506-520 12TH AVE E RECOMMENDATION MEETING

506-520 12TH AVE EAST
SDCI# 3026514-LU

BOARD FEEDBACK/GUIDANCE

APPLICANT RESPONSE

EDG RESPONSE OVERLAYS

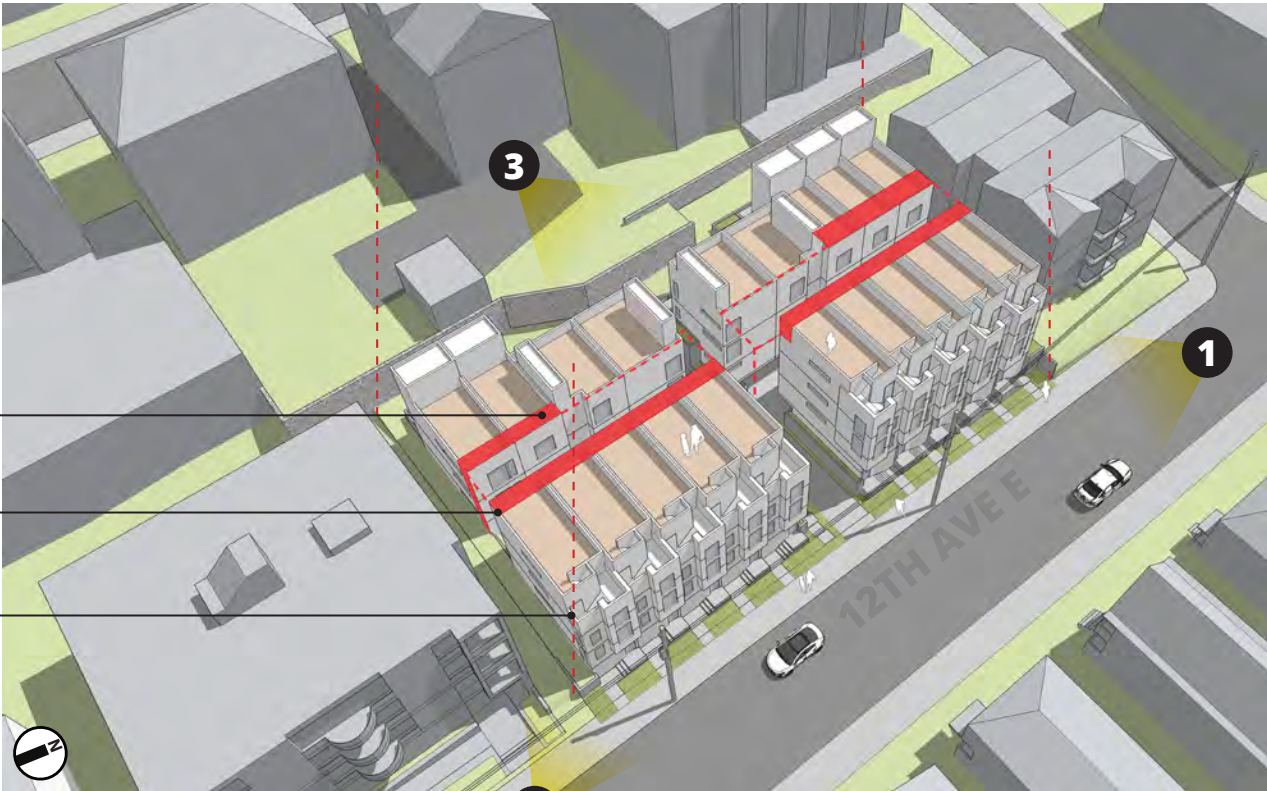
B. The Board had concerns with the stairwell on the west side (street facing front) of the units along 12th Avenue East and how this will engage the street. Several Board members commented that the idea of “eyes on the street” does not tend to happen when a stairway is located on the street facing façade of the units. Other Board members requested more information during the recommendation phase on how the proposed windows would interact with the street facing stairwell, commenting that some livable space should be incorporated in the stairwell to assist in engaging the street facing façade.

- REFINED UPPER-LEVEL ARTICULATION.
- MOVED STAIRS TO THE REAR AT STREET-FACING UNITS. ACTIVE PROGRAM NOW FACES THE STREET.
- INCREASED TRANSPARENCY AT UNITS FOR MORE CONNECTION TO THE STREET.
- INCREASED FRONT SETBACK AND SIDEWALK WIDTH FOR MORE RIGHT-OF-WAY SEPARATION.
- CENTRAL PEDESTRIAN AND VEHICULAR ENTRY MAINTAINED.
- RIGHT-OF-WAY STREET TREE RHYTHM MAINTAINED AND ENHANCED.

- MAINTAINED CENTRAL STAIR ALIGNMENT.
- ADDITION OF LANDSCAPE ELEMENTS AT ROOF DECKS.
- REMOVED ROOF PENTHOUSES BUT MAINTAINED ROOF ACCESS.
- BUILDING SEPARATION INCREASED BETWEEN ALL UNITS FACING COURTYARD.
- PARAPETS STEP DOWN FURTHER REDUCING HEIGHT AND BULK.
- STAIRWELLS MOVED TO REAR OF UNIT.

A VIEW FROM DRIVEWAY LOOKING EAST
PEDESTRIAN ELEMENTS

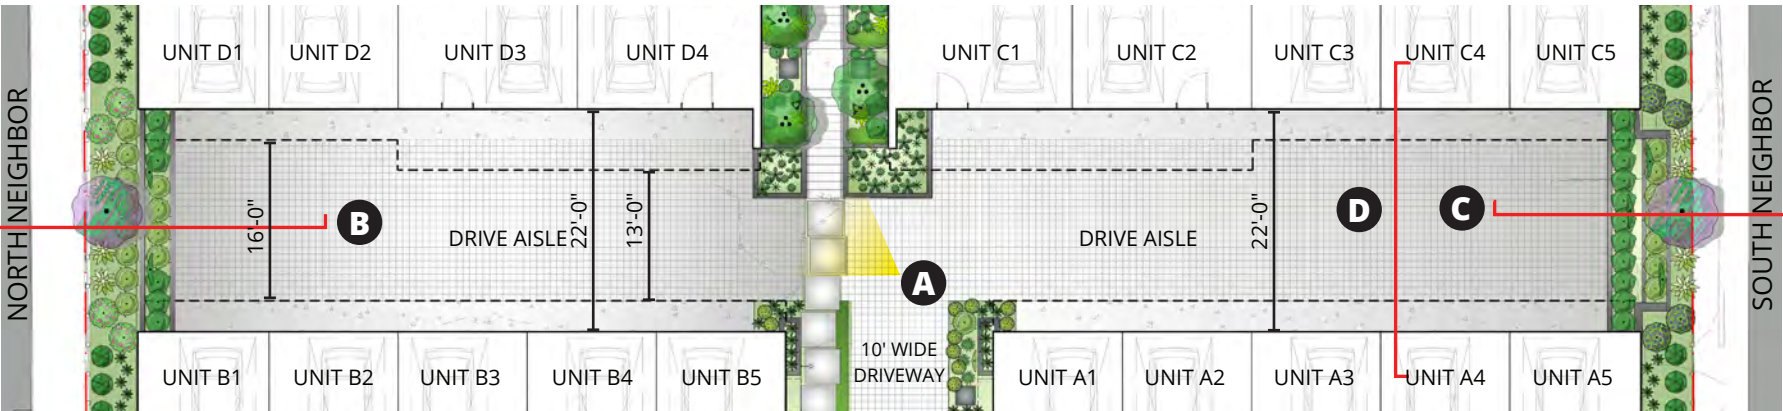
A. The Board felt strongly that it was important the pedestrian path from the sidewalk along 12th Avenue East be separated and not shared with the vehicle driveway off the street.

A. The Board reiterated the public comment regarding individual trash and recycling collection. The Board agreed with the developer that trash and recycling for all units should be consolidated and taken care of by the homeowner’s association. The Board requested additional information as part of the recommendation phase regarding the trash/recycling collection strategy, location, and proposed screening of the trash area.

F TRASH ENCLOSURE
- CLEAR WOOD SLATS, POSTS AND FRAME, EBONY STAIN
- LATCH HARDWARE, BLACK FINISH

- COMMON PEDESTRIAN ELEMENTS ARE LOCATED BETWEEN BUILDINGS AND ARE HIGHLY VISIBLE TO ENCOURAGE INTERACTION AMONG RESIDENTS. LANDSCAPING ENHANCES THE EXPERIENCE. *PL3.B.4: INTERACTION*

- CENTRAL SITE ENTRY AND ALIGNMENT WITH STAIR TO EAST UNITS IS MAINTAINED. LIGHTING AND SIGNAGE AID IN WAYFINDING. *PL2.D.1: DESIGN AS WAYFINDING*
- DISTINCT PAVING AND LOW-LEVEL PLANTING SEPARATE VEHICLE AND PEDESTRIAN PATHWAYS CREATING SAFE AND ATTRACTIVE CONDITIONS FOR PEDESTRIANS. *DC1.B.1: ACCESS LOCATION AND DESIGN*

- TRASH ENCLOSURE IS RECESSED INTO SITE RETAINING TO MINIMIZE VISIBILITY AT THE STREET. THE EXPOSED EDGES ARE INTEGRATED INTO THE OVERALL SITE DESIGN. *DC1.C.4: SERVICE USES*

B SECTION - NORTH RETAINING WALL

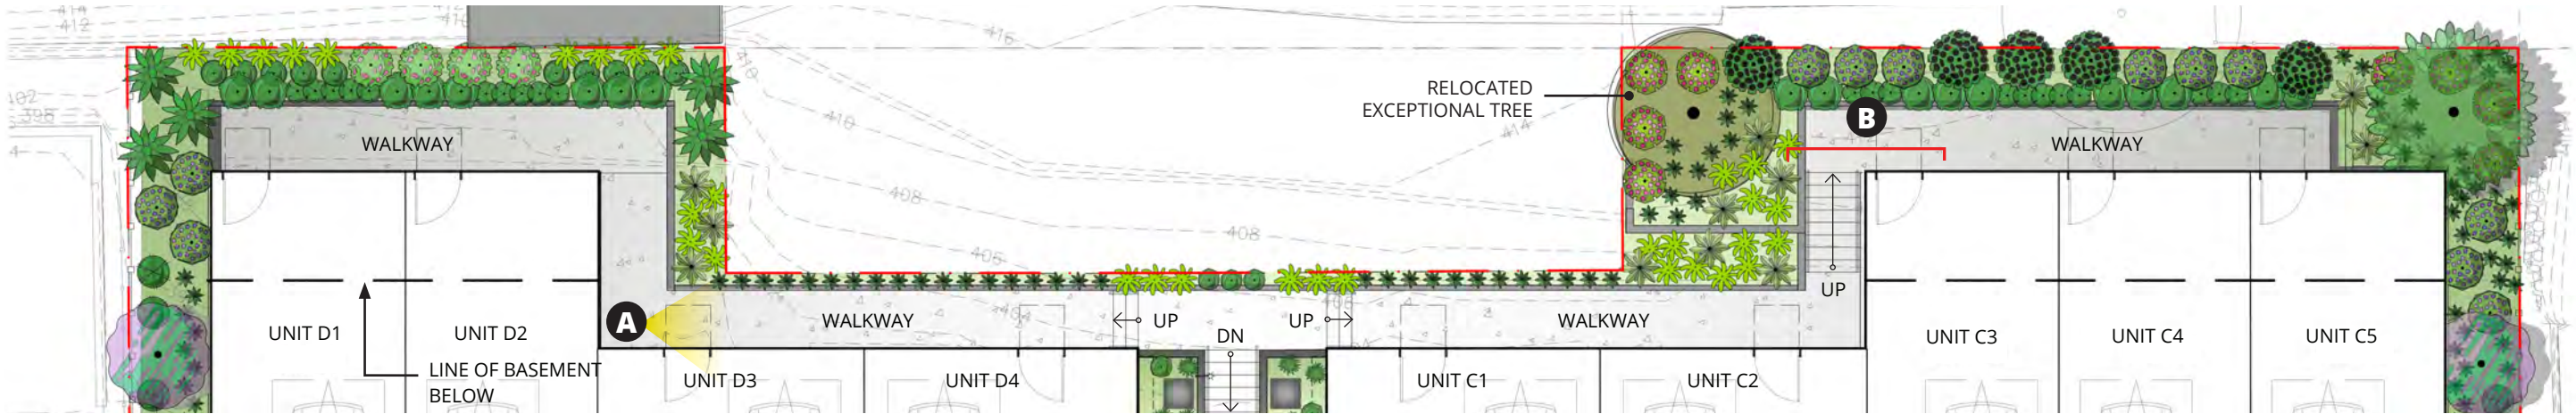
A. The Board recommended the application include material call outs for the retaining walls and detailed landscaping to help soften the visual impact high retaining walls can have and, in turn, create a livable interior courtyard space. Please include cross-sections of the walls proposed on the north and south sides of the interior courtyard demonstrating how the wall heights will be broken up.

The Board requested the recommendation phase include renderings of how the retaining walls would look from the interior courtyard of the project, for both the north and south retaining walls.

- TERRACED PLANTERS AT EACH END OF THE DRIVE AISLE INCLUDE PLANTING THAT WILL RESPOND TO THE VARIETY IN DAYLIGHTING THROUGHOUT THE DAY. CLIMBING PLANTS ARE INCORPORATED TO TREAT LARGE RETAINING WALLS. *DC2.B.2: BLANK WALLS*

- USE OF CIP CONCRETE AND EXPOSED SHORING WALLS ADD TEXTURE AND INTEREST AT THE ENDS OF THE DRIVE AISLE. *DC2.D.2: TEXTURE*
- PAVING MATERIALS ARE VARIED AND DURABLE. PERMEABLE PAVING IS THE DOMINANT APPLICATION AND IS PROVIDED AS A MEANS TO TREAT STORMWATER ON SITE. *DC4.D.2: HARDSCAPE MATERIALS*

- ENTRY LEVEL TO EAST UNITS IS RAISED TO REDUCE OVERALL RETAINING WALL HEIGHTS. *CS1.C.2: ELEVATION CHANGE*
- PENTHOUSE BULK REMOVED FROM EAST UNITS WHILE MAINTAINING ROOF ACCESS. SIGNIFICANTLY REDUCING MASS AT THE REAR OF THE SITE PROTECTS NEIGHBOR'S VIEWS WEST AND CREATES A UNIQUE, VARYING ROOFLINE. *CS2.D.5: RESPECT FOR ADJACENT SITES*
- USE OF CIP CONCRETE AND EXPOSED SHORING WALLS ADD TEXTURE AND INTEREST ALONG THE EAST WALKWAY. *DC2.D.2: TEXTURE*
- CONTRASTING MATERIALS, SIGNAGE, LIGHTING, CANOPIES, AND LANDSCAPING ARE COMPOSED TO DEFINE UNIT ENTRIES *PL3.A.2: ENSEMBLE OF ELEMENTS*
- EXCEPTIONAL TREE (VINE MAPLE) WILL BE RELOCATED TO THE EAST EDGE OF THE SITE FOR ENHANCED LANDSCAPING.
- PEDESTRIAN SCALE LIGHTING PROVIDED TO ENHANCE UNIT ENTRIES AND ILLUMINATE WALKWAYS FOR A SAFER RESIDENT EXPERIENCE. *PL2.B.2: LIGHTING FOR SAFETY*

DEPARTURES: PROPOSED

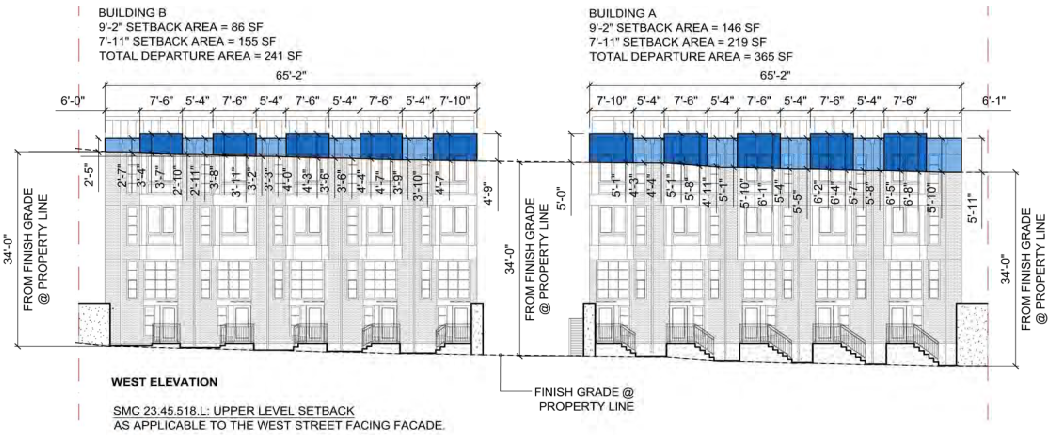
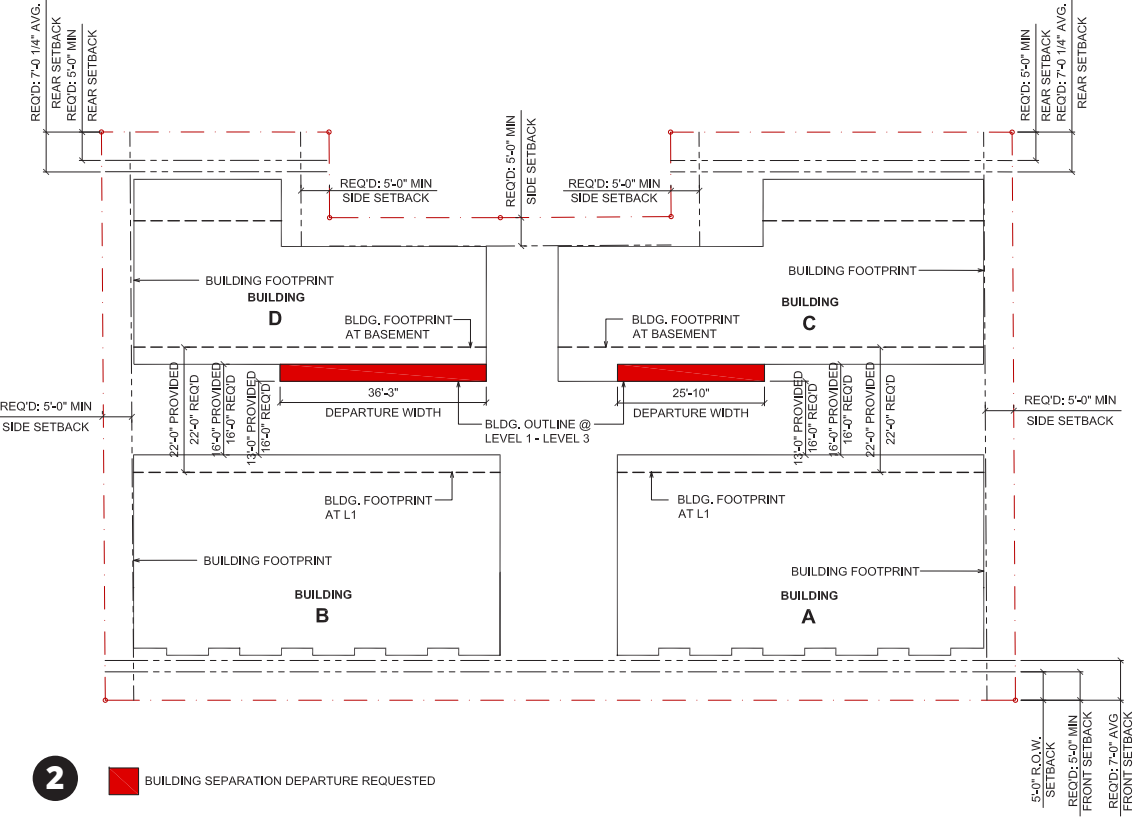
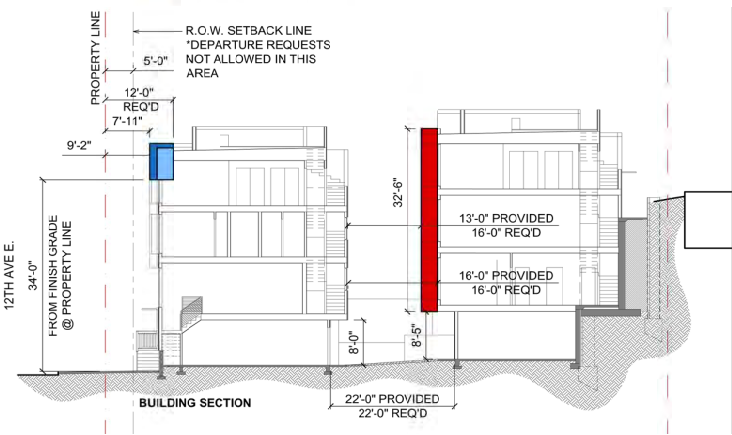
A. The Board had concerns that the interior courtyard, being a major component of the development site, sits in a canyon, leading to dark spaces and potentially limited areas where landscaping could thrive. See departure discussion 2 (Driveway Overhang Separation in LR3 Zone) on page 6 of this report.

1 DEPARTURE:
SMC 23.45.518.L - UPPER LEVEL SETBACK FROM STREET LOT LINE
REQUIRED:

BUILDING A: 7' - 11" SETBACK = 219 SF
9' - 2" SETBACK = 146 SF
TOTAL = 365 SF DEPARTURE AREA
BUILDING B: 7' - 11" SETBACK = 155 SF
9' - 2" SETBACK = 86 SF
TOTAL = 241 SF DEPARTURE AREA

- INCREASED FRONT SETBACK TO 7' - 11" AND 9' - 2" – PREVIOUSLY 5' - 0" AND 7' - 0" AT EDG.
- THE INCREASED RIGHT-OF-WAY SEPARATION AND REFINEMENT OF UPPER-LEVEL ARTICULATION MAINTAINS THE PROJECTS GOAL TO PROVIDE A CONSISTENT ARCHITECTURAL FORM ALONG THE STREET AND NOT ERODE THE STREET WALL.
- CH-CS2.I: STREETScape COMPATIBILITY, DC2.C.1: VISUAL DEPTH & INTEREST**
- ROOF DECK PARAPETS ARE HELD BACK FROM THE WEST FAÇADE TO FURTHER REDUCE THE IMPACT OF THIS REQUEST.
- DC2.A.2: REDUCING PERCEIVED MASS**
- OVERALL HEIGHT OF BUILDINGS (DEPARTURE AREA INCLUDED) IS BELOW THAT OF NEIGHBORING BUILDINGS TO THE NORTH AND SOUTH. THE PROPOSED HEIGHT IS IN KEEPING WITH EXISTING CONTEXT.
- CH-CS2.II: HEIGHT, BULK AND SCALE COMPATIBILITY, CS2.A.2:ARCHITECTURAL PRESENCE**

2 DEPARTURE:
SMC 23.45.518.F - STRUCTURE SEPARATION W/ DRIVEWAY
REQUIRED:

BUILDING C: 13' - 0" SEPARATION AT 8' - 0" ABOVE GRADE FOR 25' - 10" OF FAÇADE LENGTH
BUILDING D: 13' - 0" SEPARATION AT 8' - 0" ABOVE GRADE FOR 36' - 3" OF FAÇADE LENGTH
(NO DEPARTURE REQUIRED FOR BUILDING A OR B OR UP TO 8' - 0" ABOVE GRADE)

- INCREASED BUILDING SEPARATION 6' - 0" BETWEEN UNITS AT THE NORTH AND SOUTH. INCREASED BUILDING SEPARATION 3' - 0" BETWEEN CENTRALLY LOCATED UNITS. ELIMINATED DEPARTURE REQUEST AT 15 OF 19 UNITS FACING THE COURTYARD. BUILDINGS A AND B ARE NOW COMPLIANT.

- AT BUILDINGS A & B EXTERIOR ROOF ACCESS HAS BEEN RELOCATED TO FACE THE COURTYARD. LOWERED, STEPPING PARAPET/GUARDRAILS REDUCES THE IMPACT OF THIS REQUEST AND ALLOWS MORE LIGHT INTO COURTYARD.

- AT BUILDINGS C & D ROOF DECK PARAPETS ARE HELD BACK SO THE ROOF FORM CAN STEP DOWN TO FURTHER REDUCE THE IMPACT OF THIS REQUEST.
- DC2.A.2: REDUCING PERCEIVED MASS**

- AT BUILDINGS C & D, THE ROOF PARAPET IS LOWERED TO REDUCE THE IMPACT OF THIS REQUEST – ALLOWS MORE LIGHT INTO COURTYARD.
- CS1.B.2: DAYLIGHT AND SHADING**

1 DEPARTURE REQUESTED
UPPER LEVEL SETBACK = 9'-2"
DEPARTURE REQUESTED
UPPER LEVEL SETBACK = 7'-11"

2 BUILDING SEPARATION DEPARTURE REQUESTED
